To:	Commercial Real Estate Management, City of Toronto Metro Hall 2nd floor 55 John Street Toronto ON M5V 3C6	Addendum No:	05
		Project No:	21025 211018
Attention:	Bonita Lee	File No:	6-2-1
		Date:	November 28, 2024
		Pages (with cover):	22
Project:	Metro Hall Toronto Early Learning Child Care Centre	Delivery:	Electronic

1.1 Addendum No. 05

TORONTO
Metro Hall Fire Station &
Early Years Child Care Centre
Renovation

C-A013

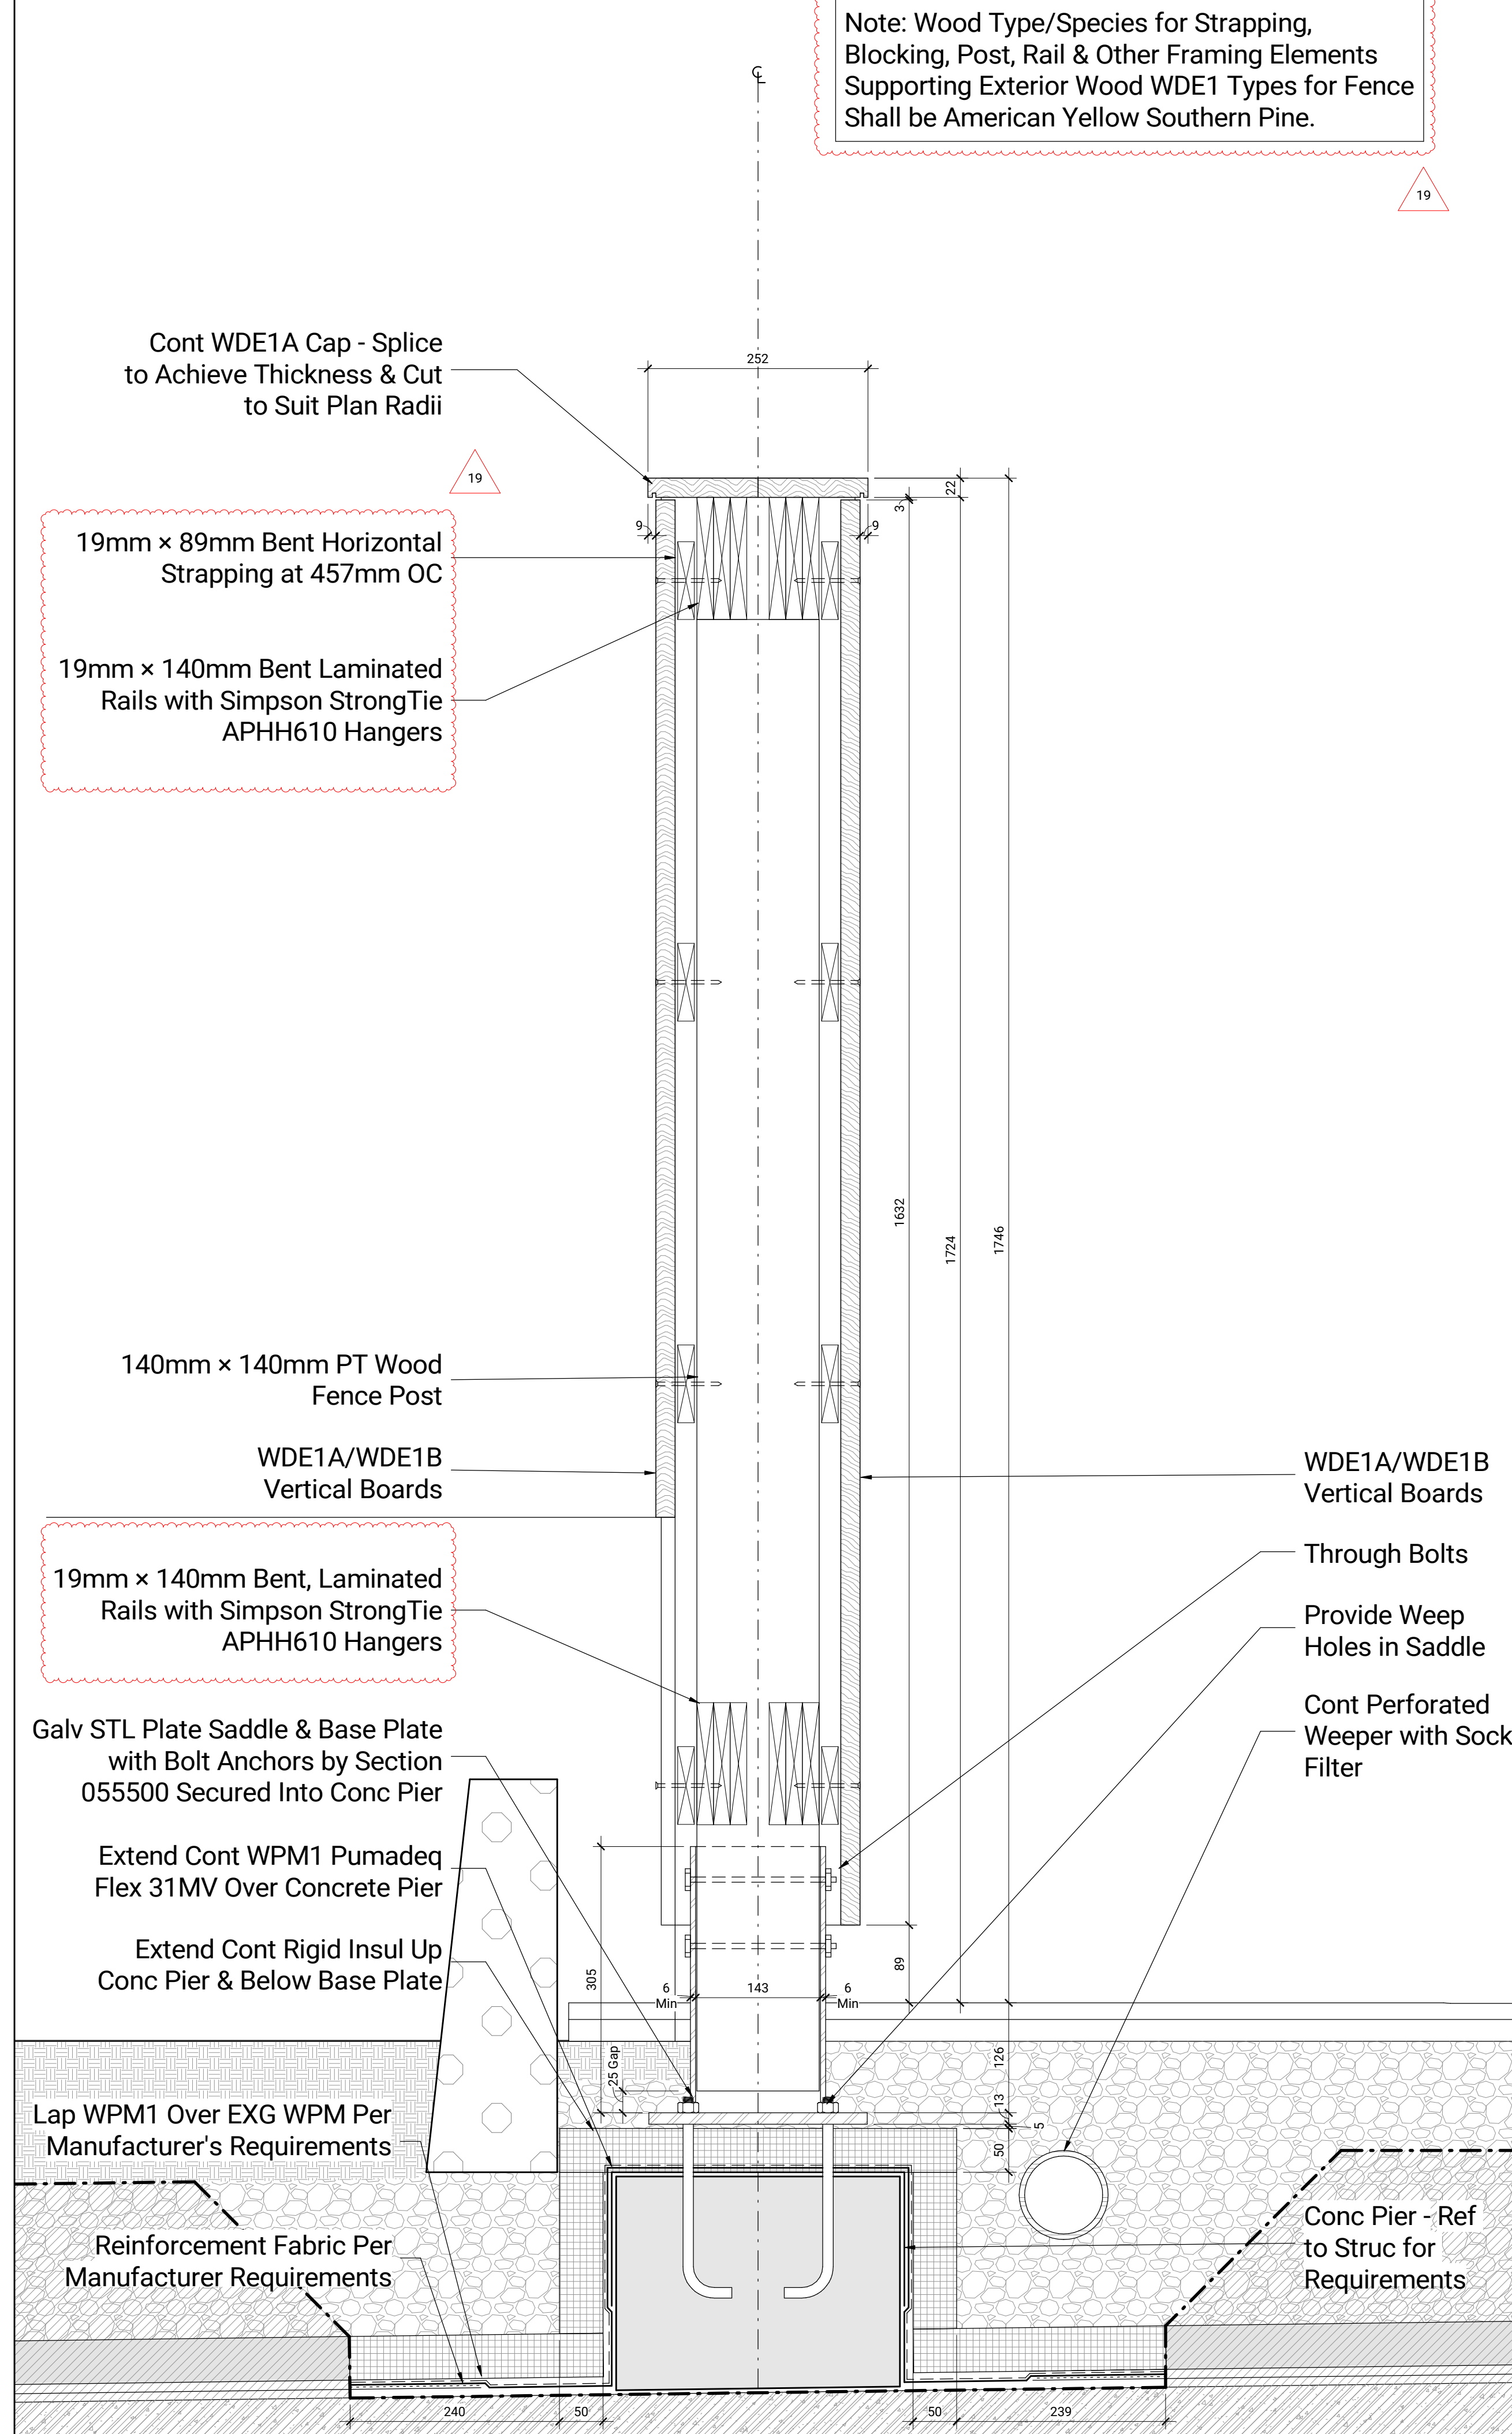
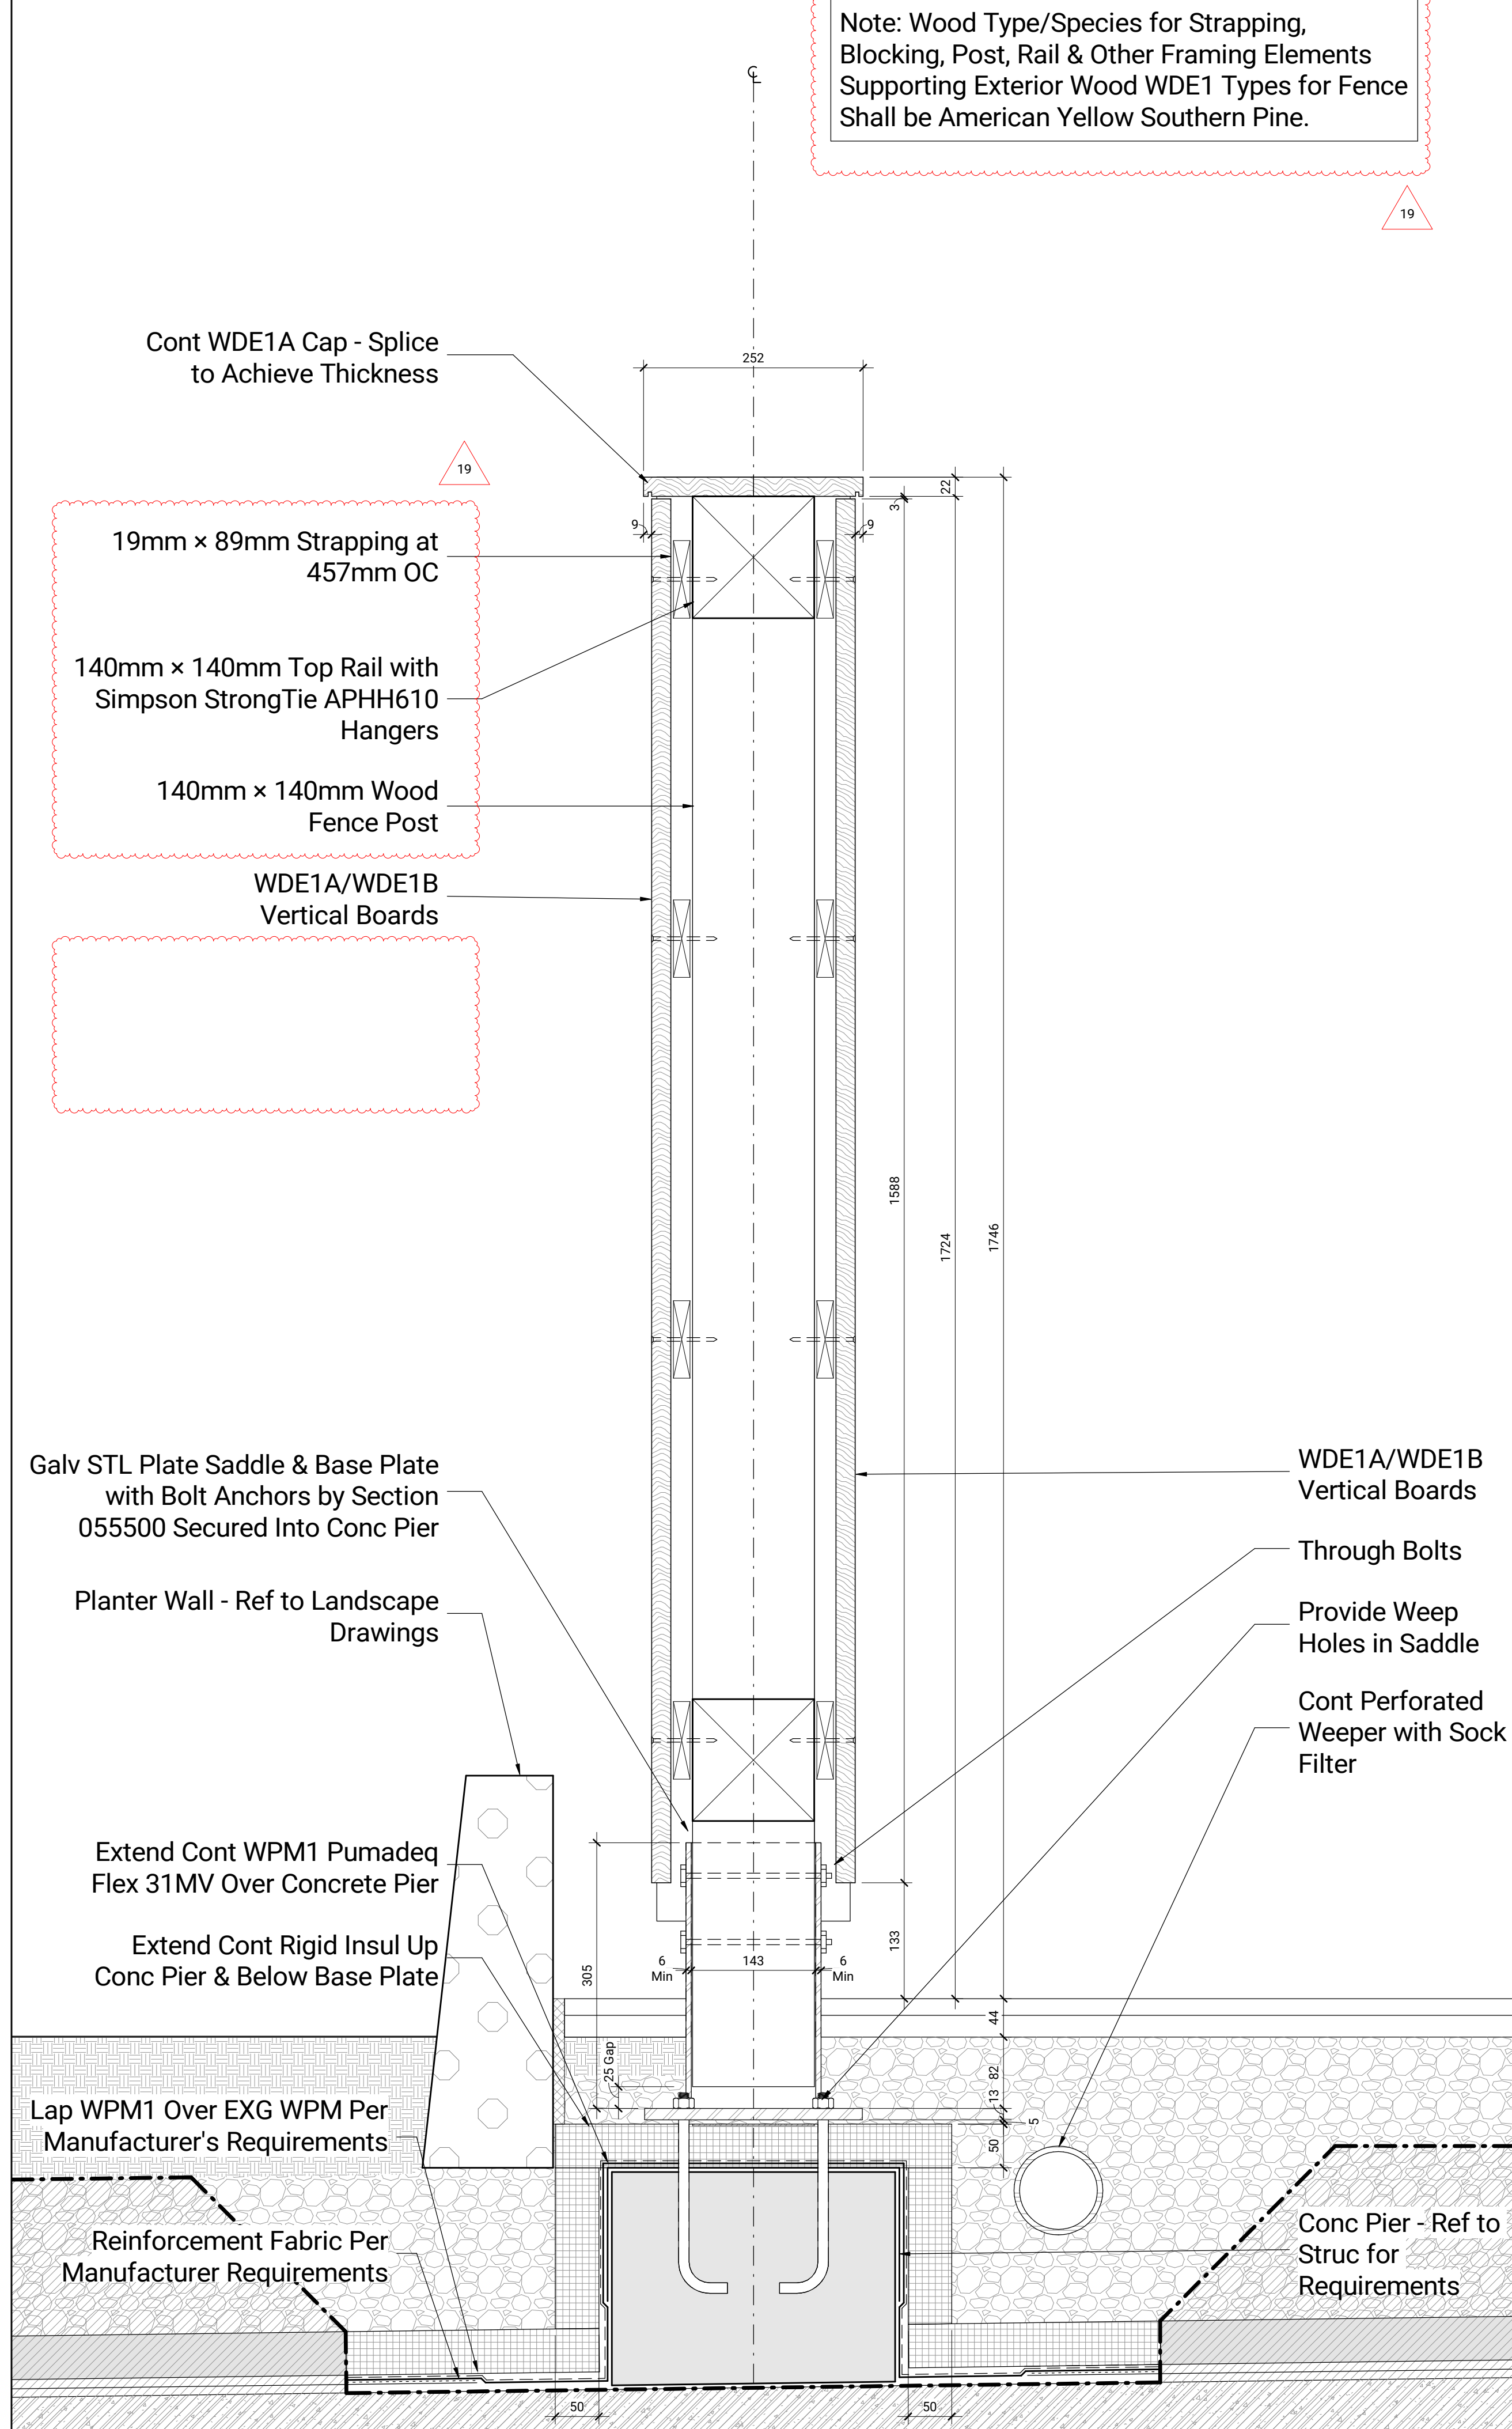
1. 1/C-A013:
 1. Revised notes for wood fence

- assembly as indicated.
- 2. 2/C-A013:
 - 1. Revised notes for wood fence assembly as indicated.

LEVEL 1 - FIRE
PROTECTION DEMO
1 : 50
DC-M-200

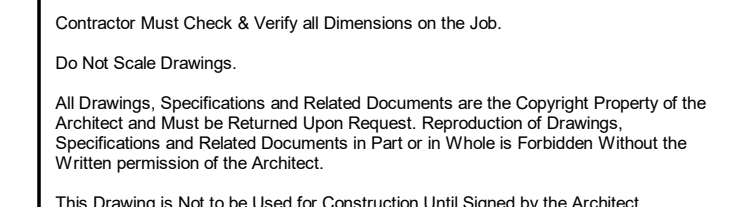
1.2. DRAWING RE-ISSUED: DC-M-200 – Level 1 Fire Protection Demo

1.2.1. Revised drawing for clarity.
